APPLICATION NUMBER FDP 76-L-071

STAFF REPORT

Applicant: Lake d'Evereaux Joint Venture

FINAL DEVELOPMENT PLAN

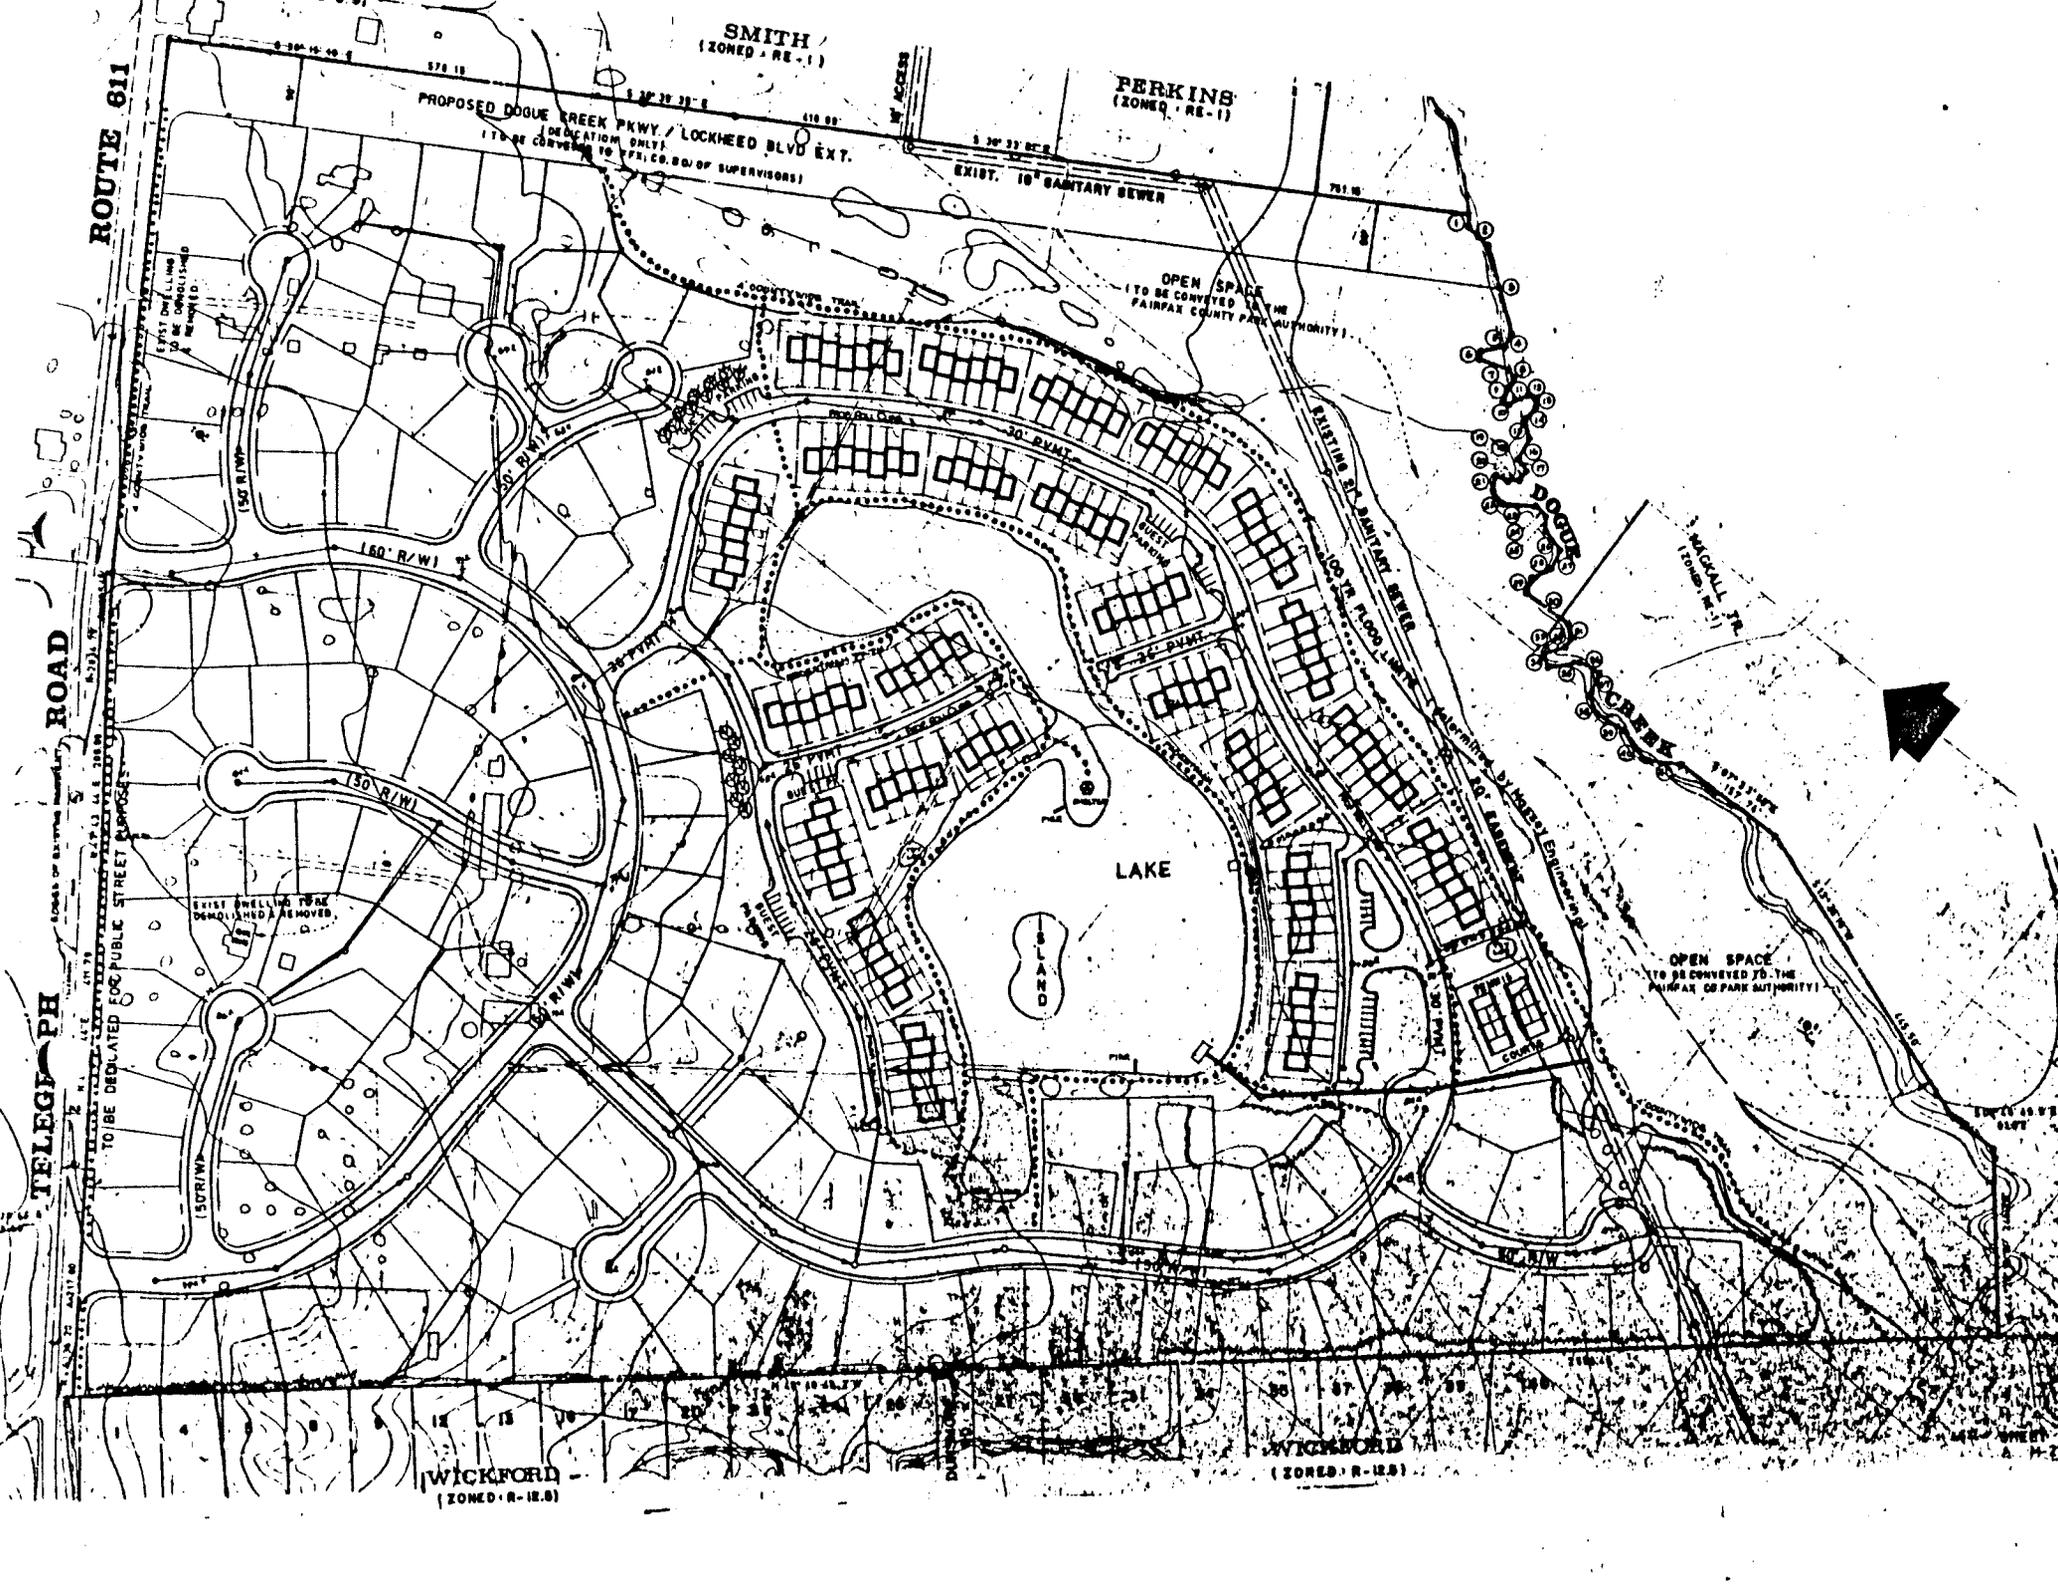
The development plan provides the two entrances to Telegraph Road and eliminates the connection to Dunsmore Road as the Board requested. The development plan also provides the proffered dedications for the Lockheed Boulevard extension and Telegraph Road. Construction will be required on Telegraph Road of right turn/ deceleration lanes at both entrances and a left turn/stacking lane at the northernmost entrance.

Stormwater Management. No additional proffers or modifications to the original staff requests are necessary. Considerable effort is being expended in this area by the applicant to assure on and off-site water quality protection objectives. An advisory note, however, is appropriate because of the applicant's proposed

excavation to achieve an enlargement of the existing on-site lake. Because of the delicate hydrologic balance and recharge mechanism for the lake, staff would urge the applicant to strongly reconsider the excavation proposal. Additional site work might interrupt that mechanism and diminish the ultimate utility of the lake. Nevertheless, if the applicant decides to proceed with the enlargement, staff would suggest that the applicant examine the potential lake circulation pattern given the summer season wind circulation patterns for this area. A stagnant area may be created by the prevailing south-southwest winds in the extreme north-northeast corner of the enlarged lake. To prevent odor or debris accumulation problems, a sub-surface pipe linkage might be advisable towards the west-southwest and the main body of the lake. This would allow the wind driven water to move out of the narrow "neck" and back into the main portion of the lake, thereby avoiding a stagnant zone. A conventional storm-sewer type of conduit would be appropriate.

Highway Noise Impact Mitigation. As discussed in the original staff report, a noise berm is still appropriate along Telegraph Road with the proposed design. The existing topography can be used to partially achieve this protection. The lots in the vicinity of the easternmost entrance should be graded down so that the small "top" will be retained as a natural berm. Fill material can then be extended along the property line to create a mound of noise berm. Landscaping measures as per the original staff report are still appropriate.

Protection against noise from the Lockheed Boulevard extension is more problematic. The new design solves much of the difficulty vis-a-vis the original development plan submission. However, the eastern tier of 7 detached lots require some additional treatment. This is particularly true of the corner lot where 2 major road facilities will intersect along the rear and side property lines. Because of the uncertainty regarding vertical alignment for these roads and their intersection, no specific noise barrier design can be proposed at this time. However, grading controls may largely mitigate the problem or at least allow the ultimate protection objective to be more reasonably achieved when the highway is constructed. It is proposed, therefore, that the applicant elevate with fill the eastern tier of lots so that Lockheed Boulevard will become a depressed road relative to the final grade of the potentially impacted lots. Should VDH&T ultimately construct the boulevard along this horizontal alignment, a low berm or wall could then be constructed so as to straddle the right-of-way line. This would then create a fairly effective noise barrier with a rather minimal effort on the part of the State and this developer. In making this suggestion, the staff assumed that the grade at the future intersection of the highway and a 4 lane Telegraph Road would be +70'. This elevation was transitioned south along the highway alignment for 200', then the highway was allowed to descend at a grade of +5%. The elevation at a spot 400' south of the aforementioned intersection would then be +60'. As proposed by the

applicant, the elevation of the lot at the property line appears to be +63'. If this elevation were increased with fill to +68' across the lot and slightly into the dedicated right-of-way an additional 4-5' high wall or berm could then be added on by the VDH&T at the time of highway construction. The effect of this action would be to split the cost and achieve a noise barrier of some 10-12' relative to the yard areas of these lots. Because considerable fill will be required for the townhouse portion of this project, it is recommended that the applicant incorporate this measure by increasing the proposed hauling effort for fill materials. Unfortunately, a 10' wide easement might need to be recorded across the rear property line of these lots so that, subject to the unanimous agreement of these property owners, VDH&T may utilize this strip for additional fill or barrier construction adequate to effectuate the ultimate noise protection barrier. A similar portion of Lockheed Boulevard dedication would be necessary to grade the barrier down to the shoulder elevation.

Vegetation Protection. Many issues have been resolved as a result of the project redesign. These comments still apply:

- a) Enlarge the vegetation protection along the property line opposite Wickford lots 37 thru 40 and south of sanitary sewer easement by moving the cul-de-sac north and slightly east, approximately 100'. With careful lot configuration vis-a-vis the sewer easement, no loss in lots need occur and the tree buffer might be increased from 10' to 60'. Obviously, structure types must also be considered here because of the proposed grade changes and tree protection objectives. Consequently, a split level or at grade house might be more appropriate than a walk-out basement type.

- b) Retain the specimen pin oaks and maples around the existing structures near Telegraph Road. If fill for the noise protection measure makes this impossible, then staff would opt to clear the trees in order to achieve the noise protection.

- c) Retain the sweet gums along the western property line and the specimen hickory near lots 4 and 5 of the Wickford subdivision.
- d) Retain internal hedgerows of small maples, sweetgums and junipers vis-a-vis property line to property line grading and related site work.

The latest version of the Final Development Plan provides a second tot lot adjacent to the tennis court. The Fairfax County Park Authority (FCPA) staff suggests that basketball/multi-use court would also be appropriate. The planning staff feels the addition of the two tennis courts exceeds the requirement for the multi-purpose court sought at time of rezoning and proffered. The dedication of land to the FCPA is essentially as requested. Countywide trail segments are shown as requested. The FCPA memorandum is Appendix 2.

The development plan indicates that Belvale, a house on the Fairfax County Inventory of Historic Sites, will be demolished. The house is suitably located on one detached residential lot to allow its preservation. At the time of initial rezoning, the applicant indicated an effort would be made to retain this house. See Appendix 3.

Stormwater Management. Studying further the proposed increase in lake size prior to site plan submission with a view to either eliminating the expansion or incorporating measures to reduce potential stagnation.

Noise Impact Mitigation. Incorporating the suggested elevations in the grading plan to provide for limited noise mitigation features along Telegraph Road and to facilitate provision of future noise attenuation measures along Lockheed Boulevard extended.

Vegetation Protection. Incorporating to the extent possible during preparation of a subdivision site plan the protective measures recommended for specific vegetative assets of the site.

Historic Site. Retaining of Belvale as a single family residence.
